STEELE MUNICIPAL AIRPORT CITY OF STEELE, MISSOURI

ADDENDUM NO. 1

State Project No. AIR 166-081B

OVERLAY AND REACTIVATE PARALLEL TAXIWAY AND END
CONNECTOR; CONSTRUCT NEW HANGAR TAXILANE; REHABILITATE
MID-FIELD CONNECTOR; REINSTALL AIRFIELD ROTATING BEACON

GRADING AND DRAINAGE PLAN

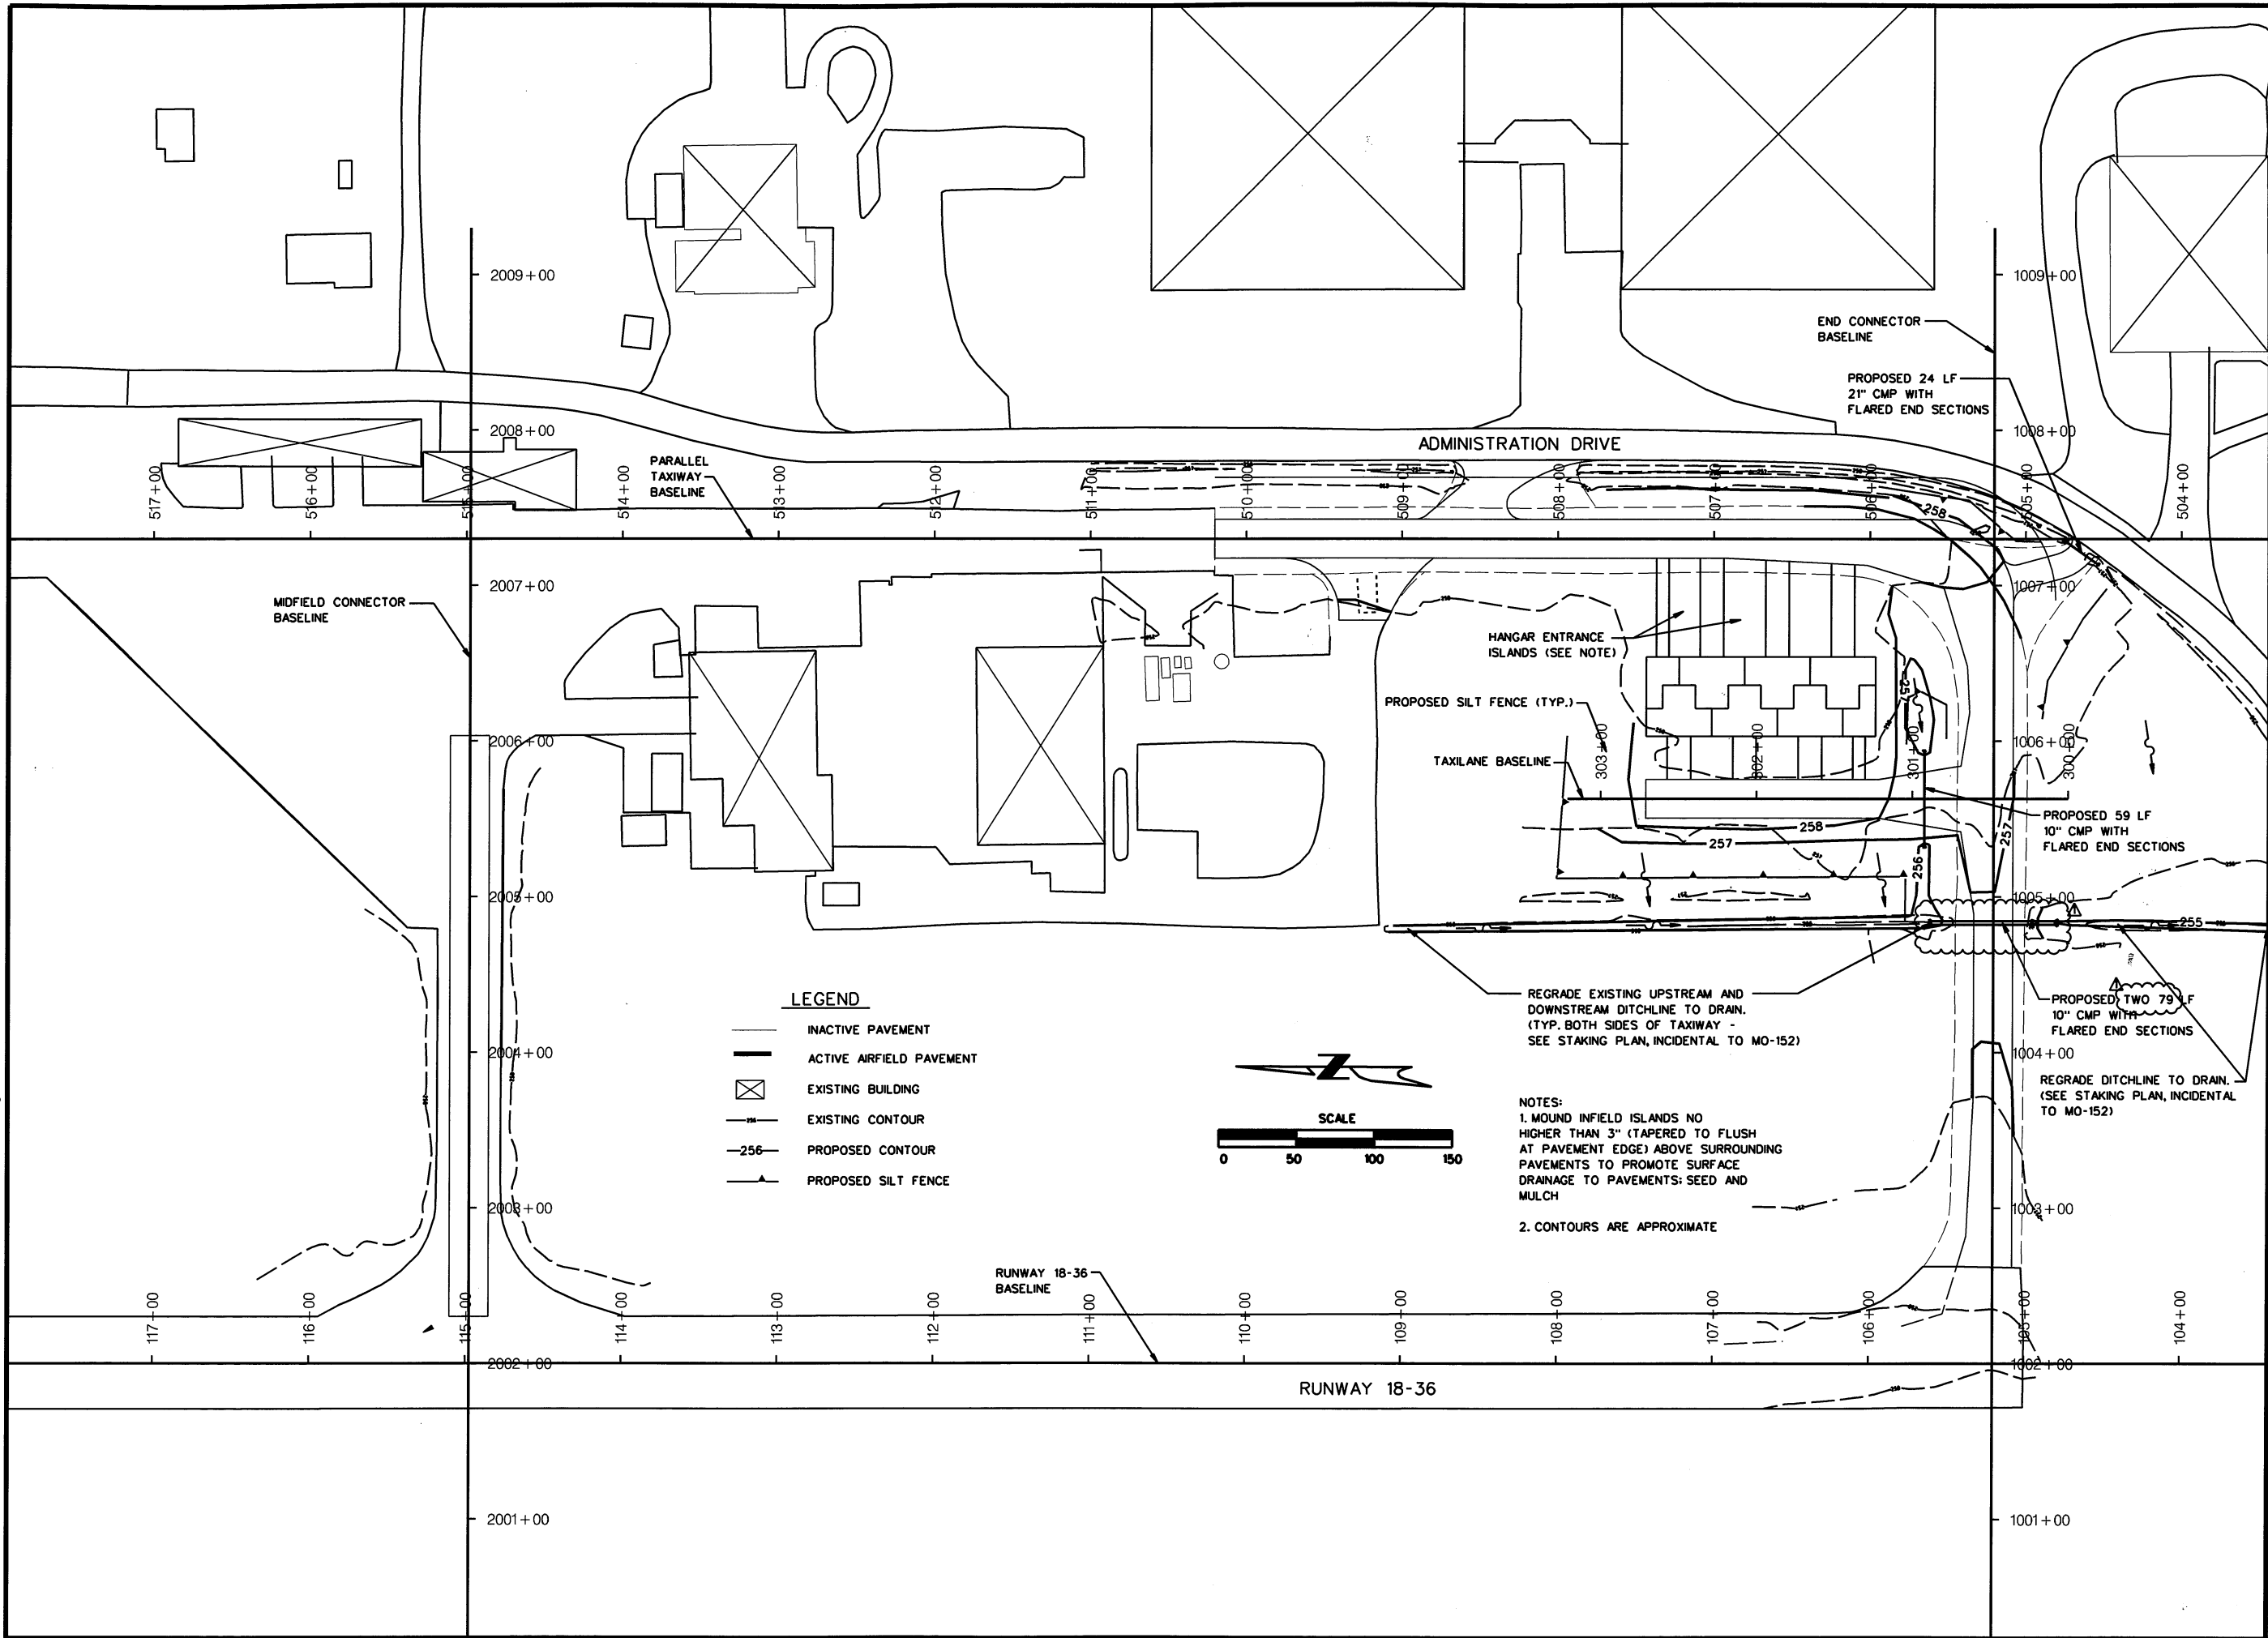
SHEET 10 OF 17 – GRADING AND DRAINAGE PLAN

DELETE: Sheet 10 of 17

ADD: Attached revised Sheet 10 of 17

CLARIFICATION: A second, parallel 10" CMP with flared end sections is added to cross the end connector at approximate station 1004+80.
